**Steven M. Clouse Water Recycling Center
Sand Drying Bed Improvements
Solicitation Number: CO-00309
Job No.: 19-6503**

**ADDENDUM 2
December 9, 2019**

**STEVE M CLOUSE WRC SAND
 DRYING BED IMPROVEMENTS
 SLUDGE BED CELL A, B, C, & D
 STRUCTURAL PLAN**
 SAWS PROJECT NO. 19-6803
 SAN ANTONIO, TEXAS

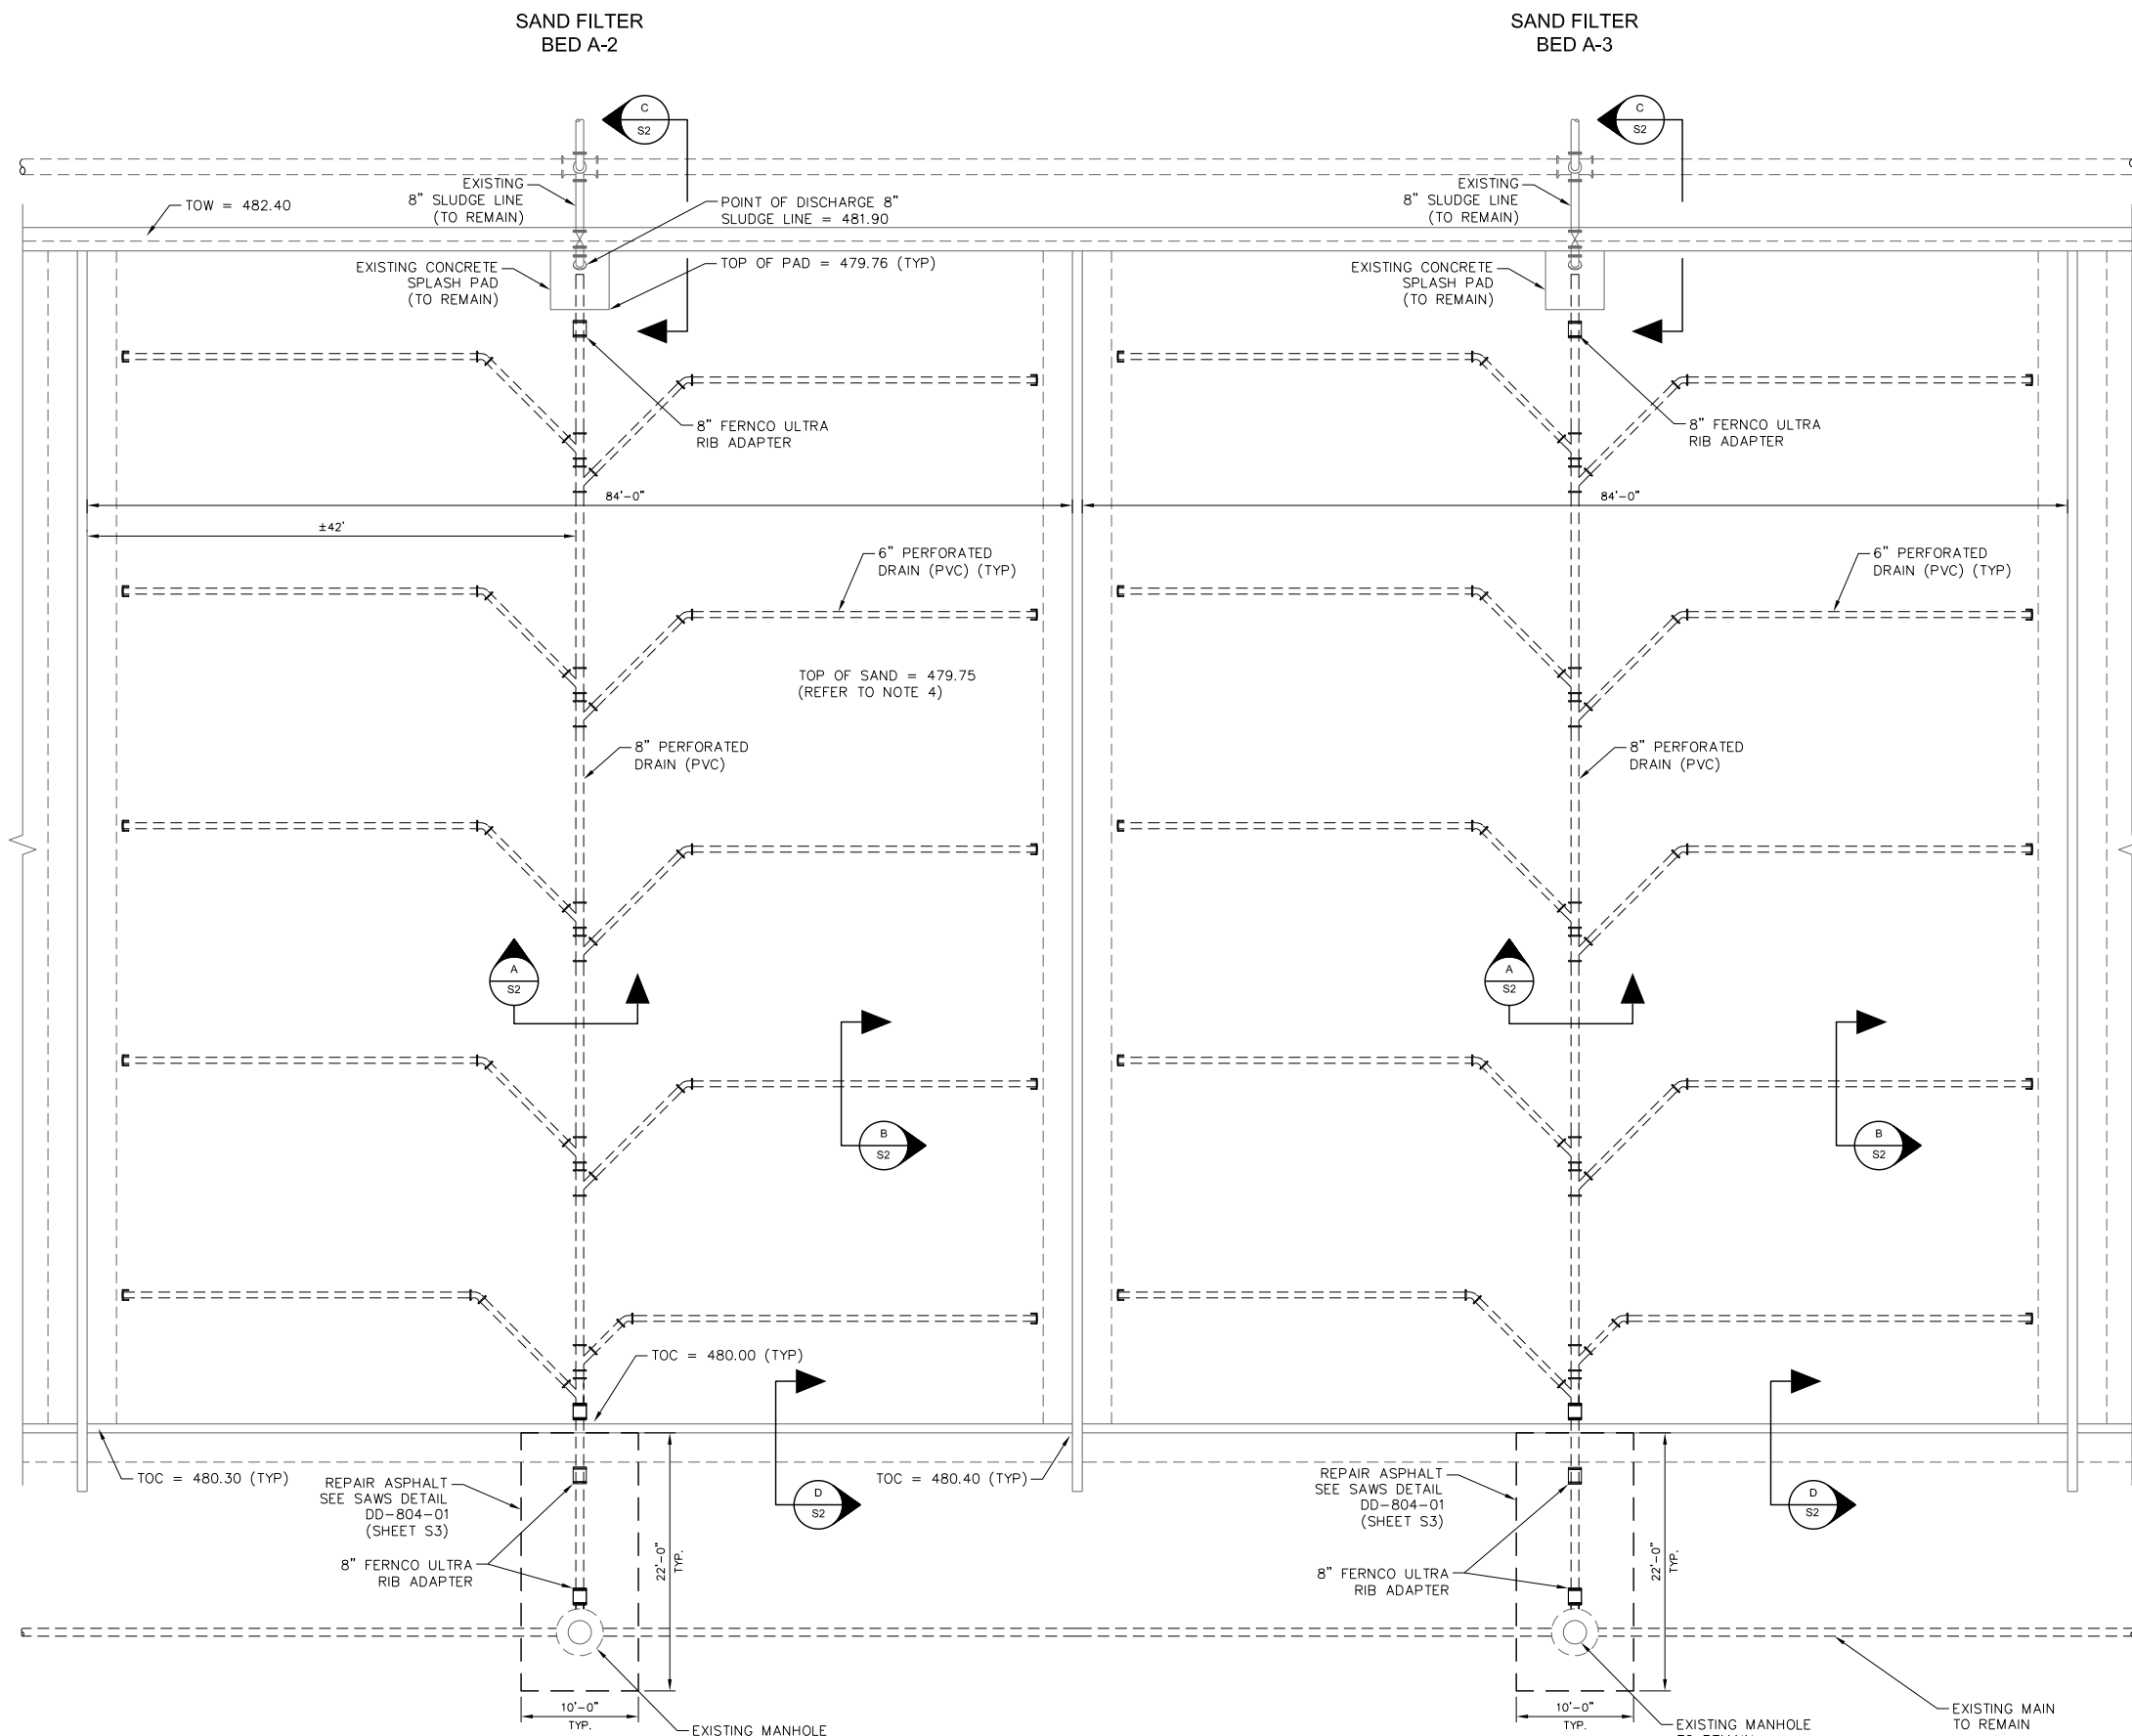
8. Sheet C 1 states Bed C-2 to remain as is. Sheet S 1 Note 1 says Bed C-3 to remain as is. Weren't both these beds C-2 and C-3 improved in a prior project? Will this change the Base Bid from 32 EA to 31 EA?

1. Sheet S-1- Sludge Bed Cell A, B, C, & D Structural Plans – Remove in its entirety and replace with the revised version attached to this Addendum.

Bed C-2 as noted on Sheet C-1 is the concrete bed that will remain as is. Note 2 on Sheet S1 should indicate Bed C-2 to remain as is. The number of beds in the base bid is 32 as shown on the Bid Form.

- REFER TO DEMOLITION PLAN (SHEET D1).
- THIS DRAWING DEPICTS BED A-2 AND A-3 AND TYPICAL OF UPGRADES REQUIRED AT ALL REMAINING BEDS (A-1 TO A-11, B-1 TO B-11, AND C-1 TO C-11). EXISTING CONCRETE DRYING BED (C-2) TO REMAIN AS IS.
- NO MORE THAN SIX (6) SLUDGE DRYING BEDS MAY BE OUT OF SERVICE AT ANY ONE TIME.
- TOP OF SAND LAYER ALL BEDS:
 - A1 TO A11= 479.75'
 - B1 TO B6= 484.75'
 - B7 TO B11= 479.75'
 - C1 TO C6= 484.75'
 - C7 TO C11= 479.75'
 - D1 TO D4= 484.75'
 - D5 TO D6= 484.75'
 - D7 TO D11= 479.75'
- FIELD VERIFY ALL ELEVATIONS PRIOR TO STARTING ANY WORK. NOTIFY ENGINEER OF ANY DISCREPANCY.
